Atellica® Solution

Atellica CH 930 Analyzer – Three issues identified in Atellica Solution Software V 1.19.2 and below

This response form is to confirm receipt of the enclosed Siemens Healthcare Diagnostics Urgent Field Safety Notice (UFSN) ASI19-04.A.OUS, dated August 2019 regarding “Atellica® CH 930 Analyzer Three issues identified in Atellica Solution Software V 1.19.2 and below”.

Figure 1. Calibration Results Screen

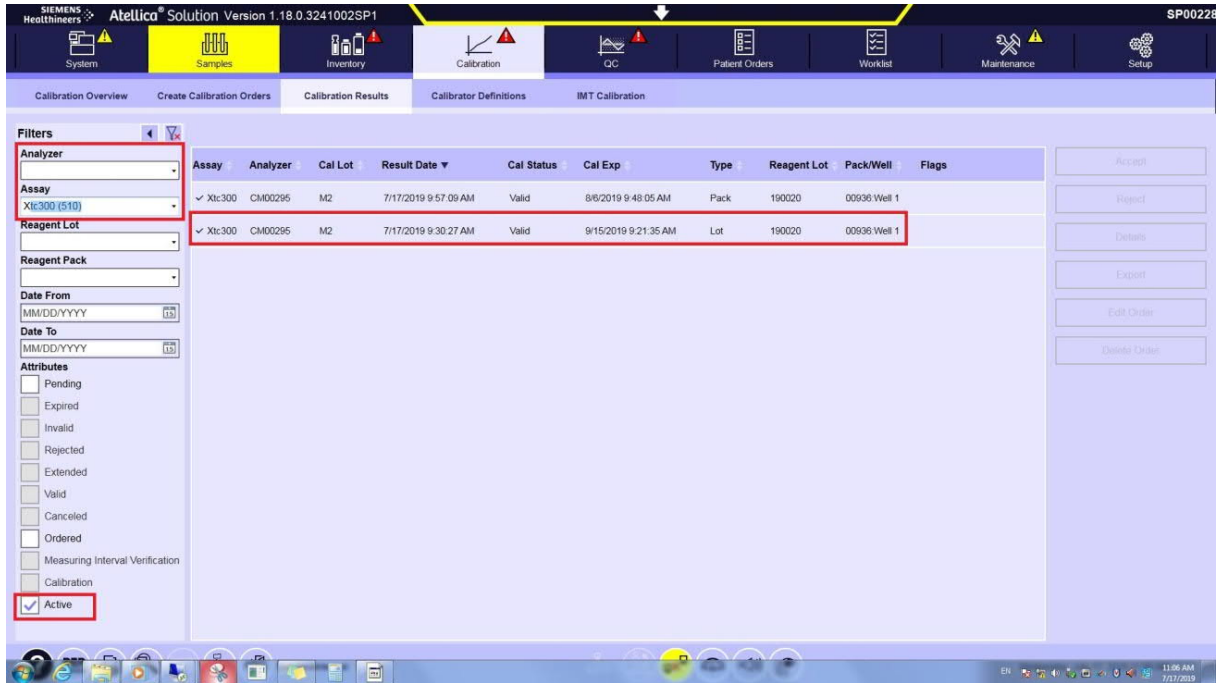
3. Upon completion and acceptance of the lot calibration, record the date and time the calibration was performed by navigating to **Calibration > Calibration Results** and filtering on the appropriate assay and analyzer. (Reference Figure 1. Calibration Results Screen)

1. Navigate to **Calibration > Calibration Results** and select the TP Assay. (Reference Figure 1. Calibration Results Screen)
2. Record the date and time of the TP Lot calibration. A lot calibration will need to be performed 181 days from the recorded date.

Figure 2. Reagent Overview Screen

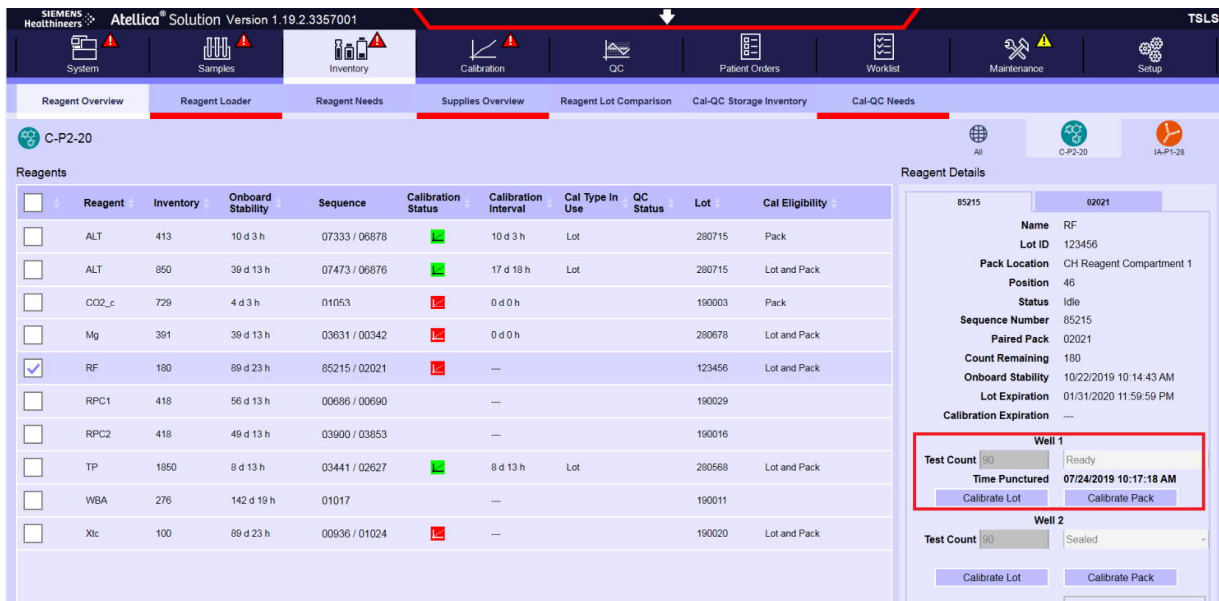
1. Load Atellica CH Rheumatoid Factor (RF) reagent packs onto the CH Analyzer. Refer to the Atellica Solution Online Help Section **Loading CH Reagents** for instructions.
2. Navigate to **Inventory > Reagent Overview** and select RF to view the Reagent Details. (Reference Figure 2. Reagent Overview Screen)
3. Record the date and time the reagent pack well(s) is opened. Please check status of each well in “Reagent Details”.
 - a. Condition #1: If both wells are punctured upon loading the reagent pack and/or the Atellica Software Version is <1.19, the entire pack must be unloaded after 21 days.
